Technical Service Bulletin: TSB120004	Released Date: 18-Jan-2012
External Oil Leaks at Rocker Housing Gasket Reduced by Loctite™ 243 Applied to the Intake Port Capscrews

03z00005

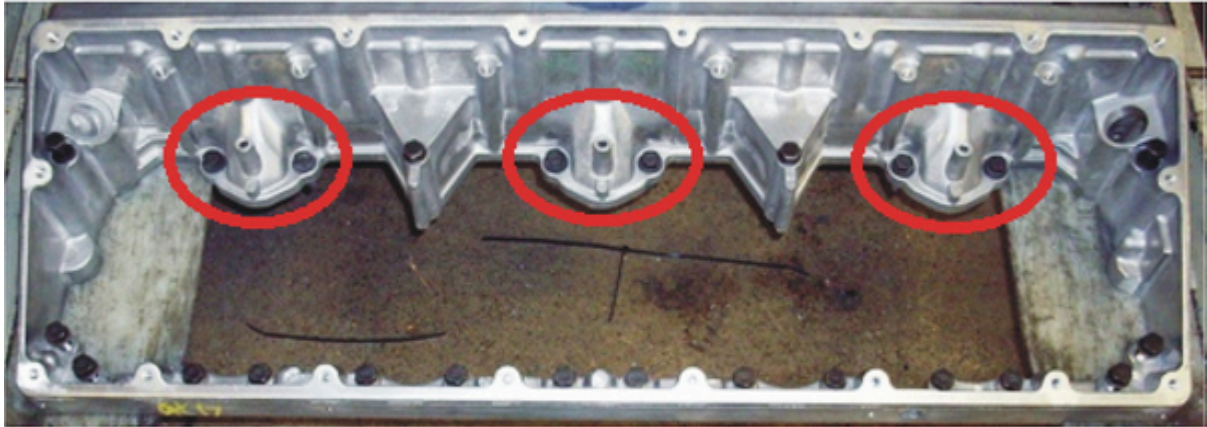
External oil leaks at the ISM rocker housing gasket are partially caused by loss of capscrew load. Cyclic thermal expansion of the aluminum housing can cause the capscrews to rotate and eventually “ratchet” loose. The six short capscrews located at the intake ports are at risk for this issue.

External oil leakage from the rocker housing gasket, especially around the intake ports.

If the rocker housing is removed during any repair, oil resistant medium strength thread locker, such as Loctite™ 243 or equivalent, should be used when assembling the six short capscrews located on both sides of the three intake ports. Reference the photograph below.
